Appendix I
for MPC Paper No. A/K13/316A

**Proposed Redevelopment of an Existing Industrial Building
With Minor Relaxation of Plot Ratio and Building Height Restrictions
at No. 33 Tai Yip Street, Kwun Tong
- S16 Planning Application -**

**Proposed Redevelopment of an Existing Industrial Building
With Minor Relaxation of Plot Ratio and Building Height Restrictions
at No. 33 Tai Yip Street, Kwun Tong
- S16 Planning Application -
TPB Ref.: A/K13/316
Further Information No. 1**

RESPONSE-TO-COMMENT TABLE

DRAWING TITLE:
GSKY GREEN WALL PANELS
CONCRETE WALL STRUCTURE / INTERIOR OR EXTERIOR
3D VIEW
PLAN DETAIL

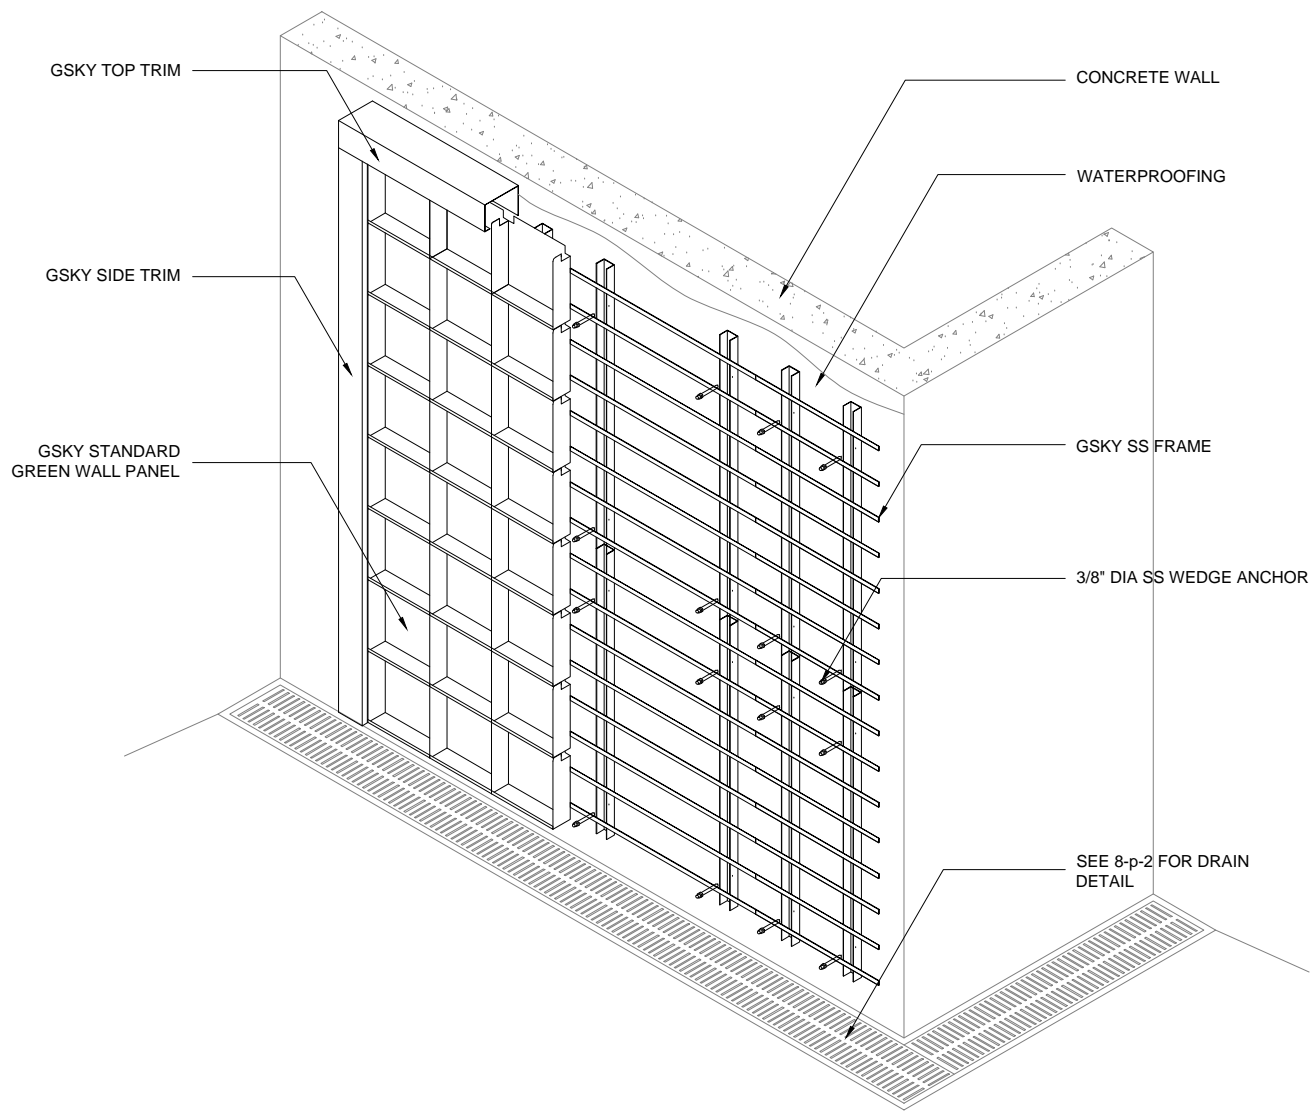
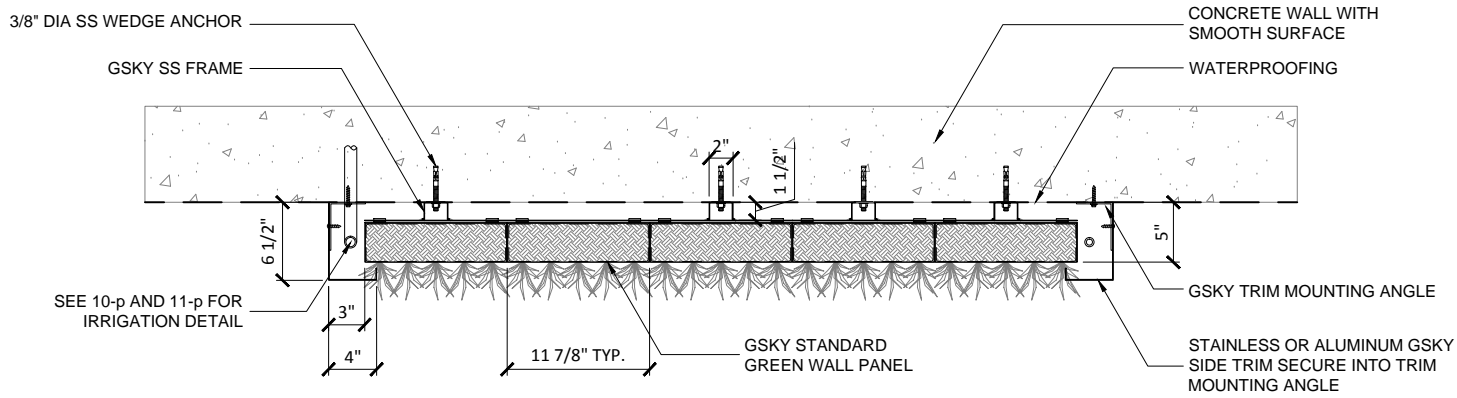
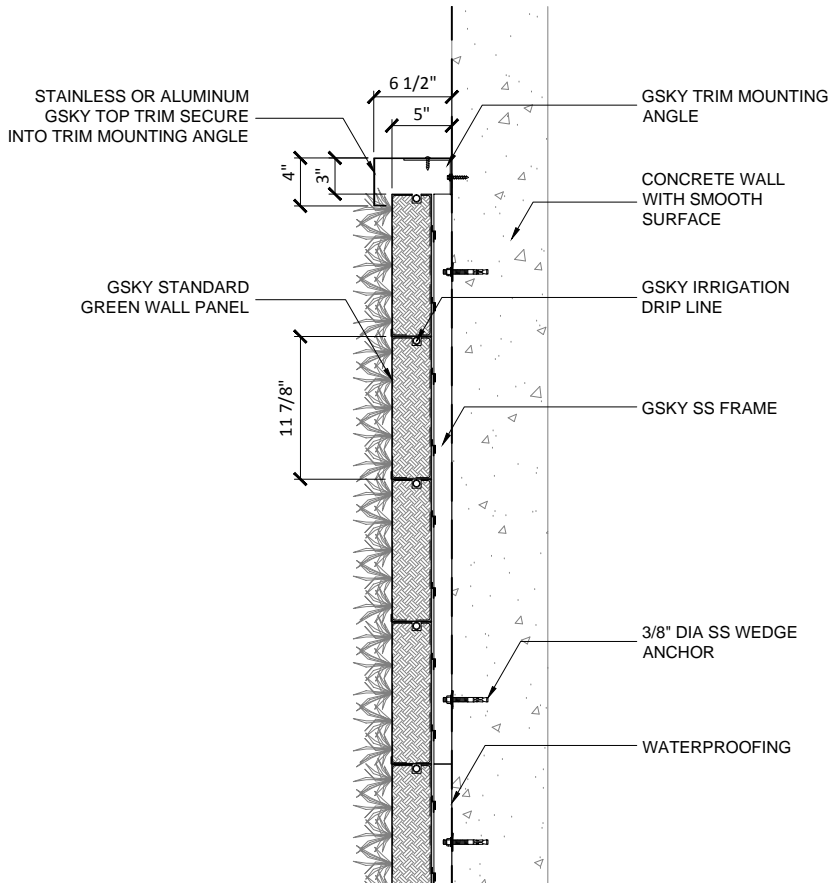
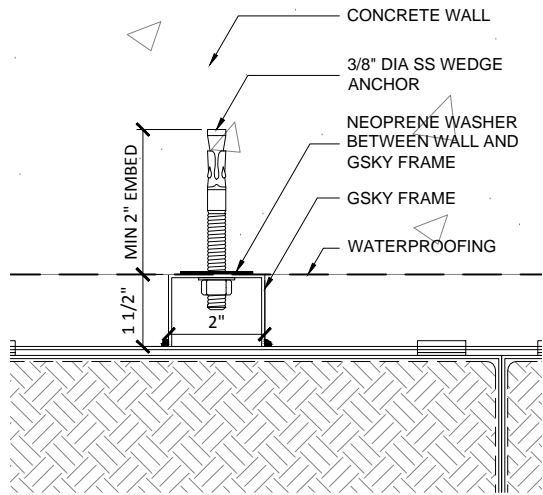
With regard to the issue on maintenance of vertical greening raised by KDPO, please refer to the attached reference drawing.
